From: Christopher Davis
Sent: 18 January 2024 16:19
Subject: RE: HGY/2023/3303- Clarendon Block D3 Verification Report Rev 2

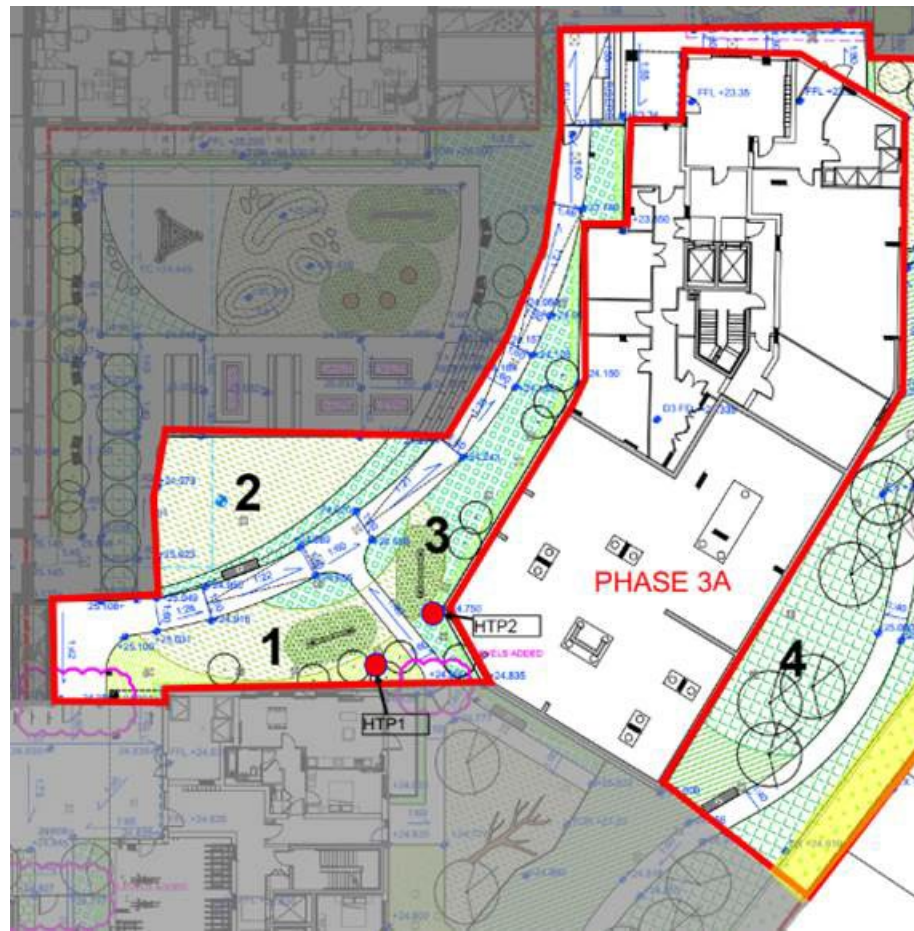
We had initially proposed to provide evidence of capping layer installation to all six zones identified in the plan below for the D3 component of PC31. Unfortunately zones 4, 5, & 6 have been delayed and we are not yet in a position to complete these areas or provide the necessary evidence.

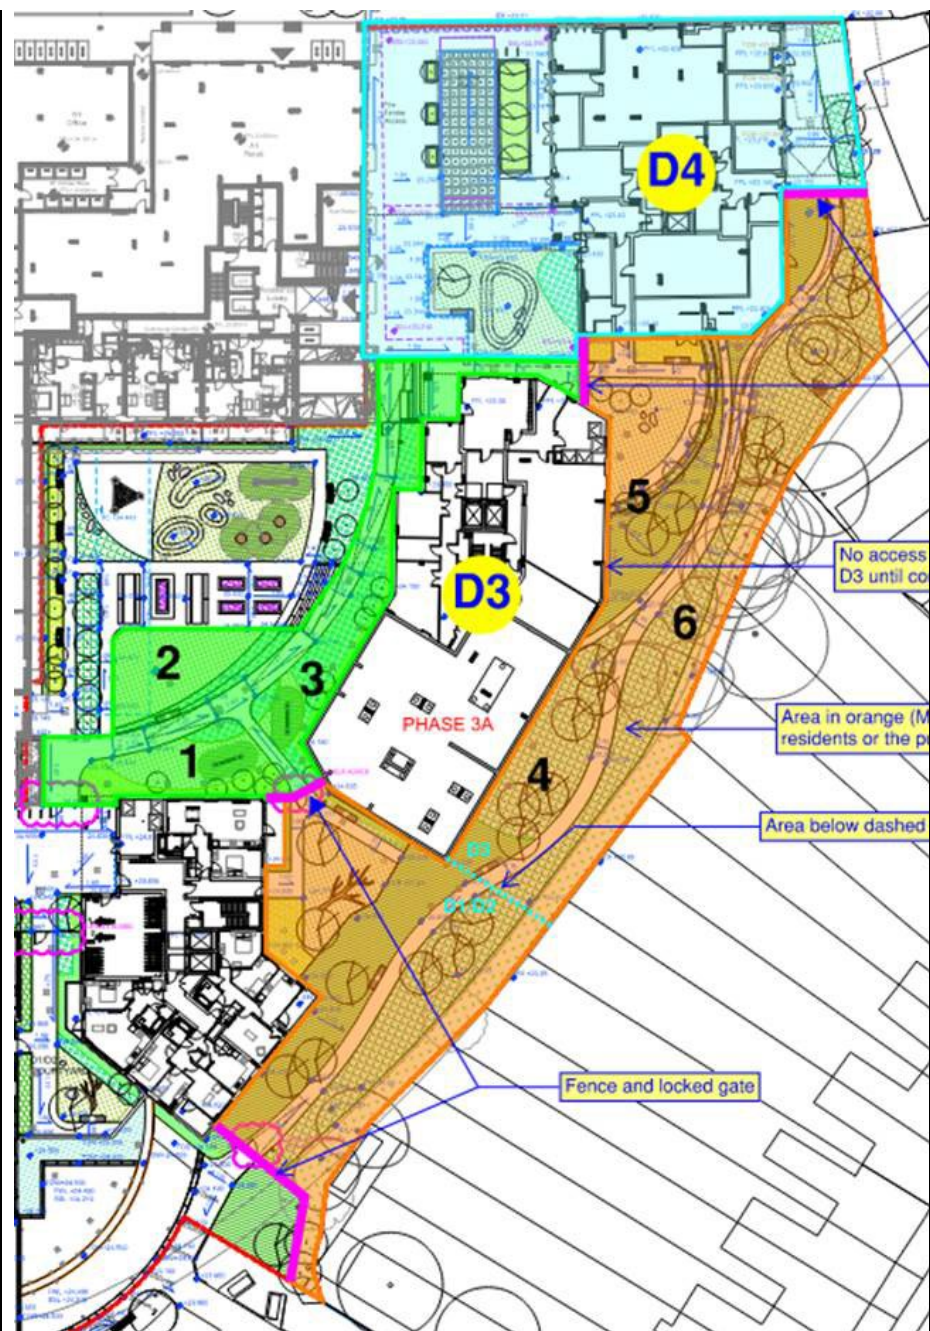
Our concern is that PC31 is a preoccupation condition and we have our first resident moving in on Friday next week. We would like to propose that we exclude zones 4, 5, & 6 from the D3 submission on the basis that this area will not be open to residents or the public. I've marked up a wider plan to explain in more detail, below right. Essentially the area in orange will not be accessible until completion of D4 in around a years' time and is secure on all sides. Neither building D2 or D3 allow access direct from the building.
